DOCUMENT NO: **OP-1903.065**

TITLE: **EMERGENCY RESPONSE FACILITY
TECHNICAL SUPPORT CENTER (TSC)**

REVISION NO: **015-00-0**

SUBJECT: **NEW REVISION**

TECHNICAL SUPPORT CENTER

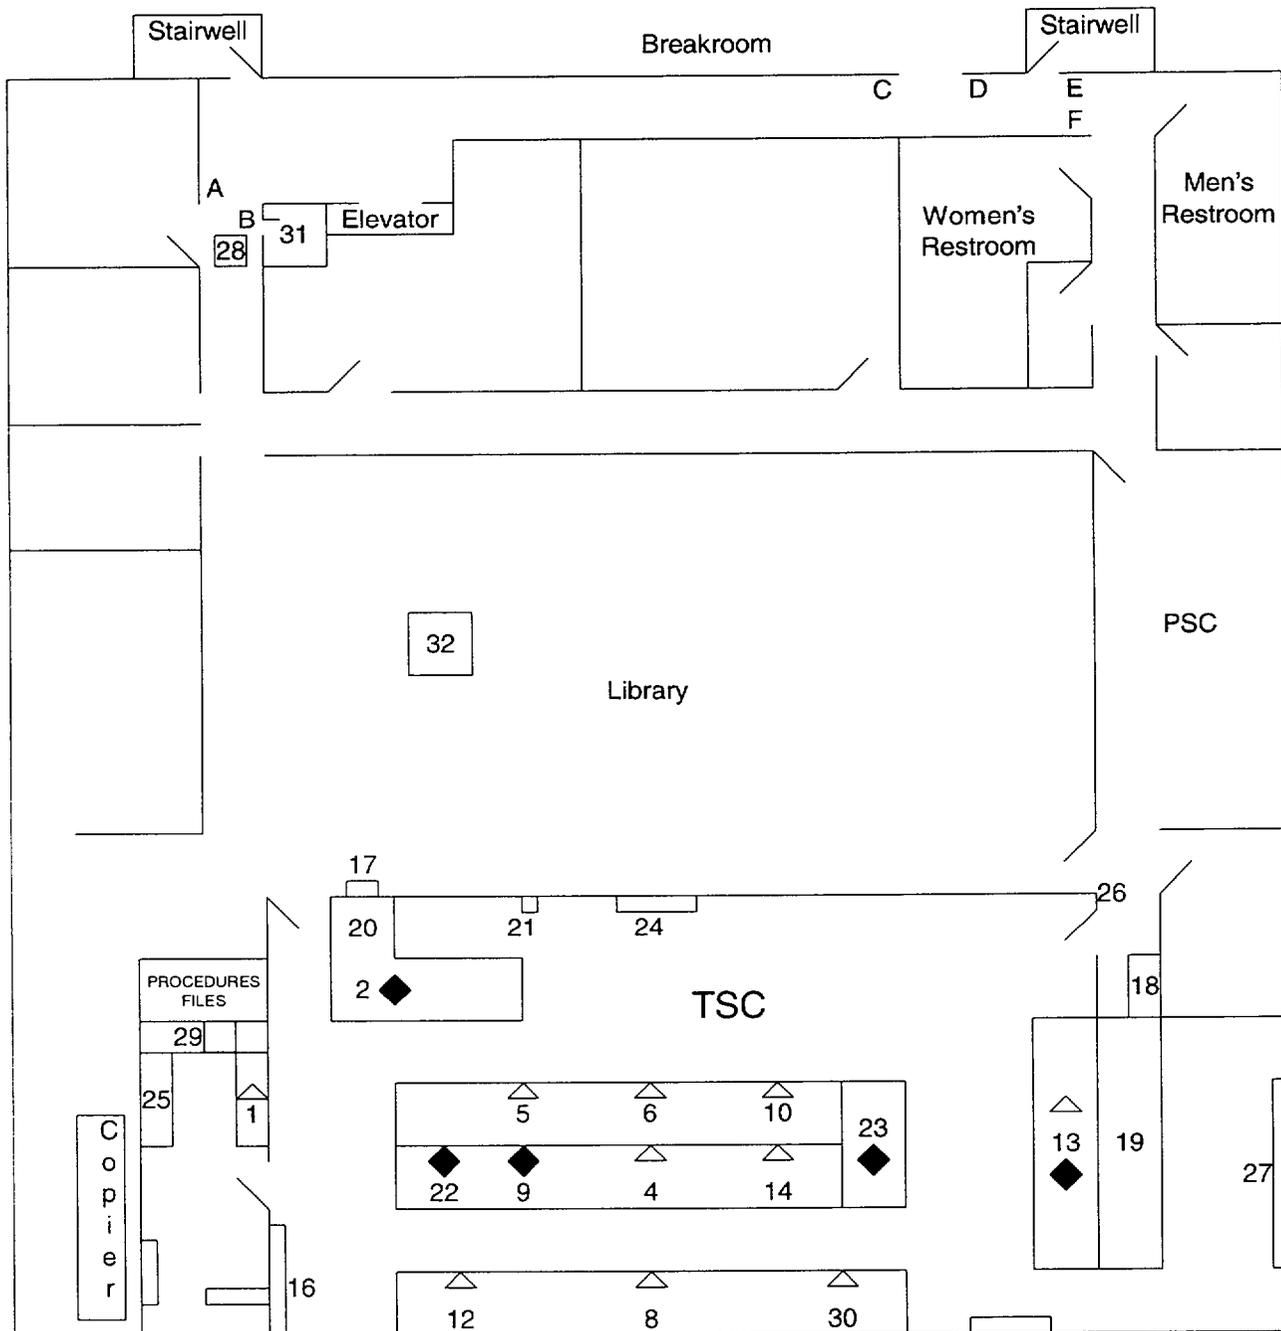
Form 19093.065C Page 2 of 2	Deleted label "13. Deleted" and renumber label 14 to label 13 and made appropriate change to the drawing.
Form 1903.065E	Added "Notifications Communicator" to the staffing form to be sent to the EOF.

TSC Layout
 (NRC Office Space Provided Adjacent To TSC)

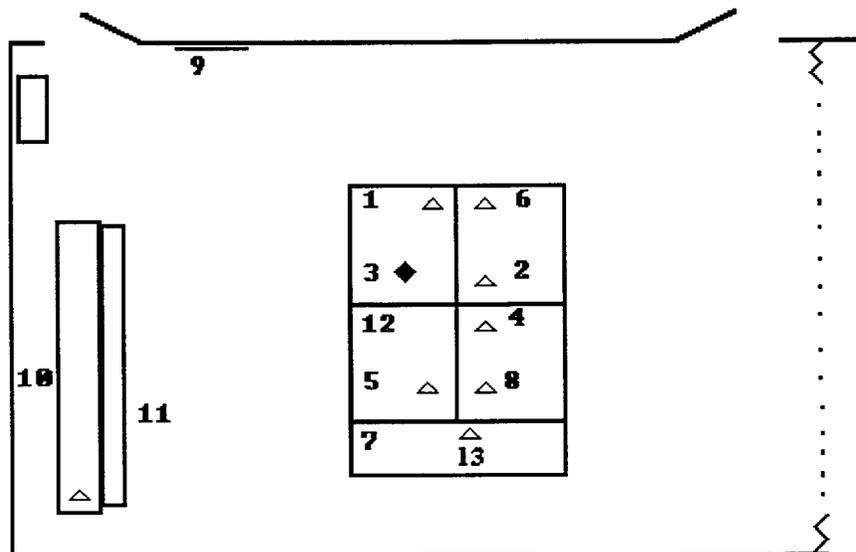
Form 1903.065A	Deleted note at top of page and incorporated it into first statement. Added the statement "Steps 1 and 2 should be performed as soon as possible. Use attached floor diagram of the TSC for location of stations." Changed step 5 to step 1 and step 6 to step 2. After step 2 added the statement "Steps 3 through 7 may be performed by the RP technician. The TSC Support Superintendent should ensure that the checklist is completed within approximately 1 hour after the TSC is operable. If a release is know to exist, then step 3 should be performed as soon as possible." Moved step 7 to step 3. Renumbered the remaining steps. Added clarification instructions to step 3. Moved the signature bar from the left side to the right side of the instructions.
Form 1903.065C Page 1 of 2	Deleted Note at top of page and incorporated into step 2. Changed note after step 3 into step 4. Renumbered as appropriate. Moved signature bar to right side of instructions.
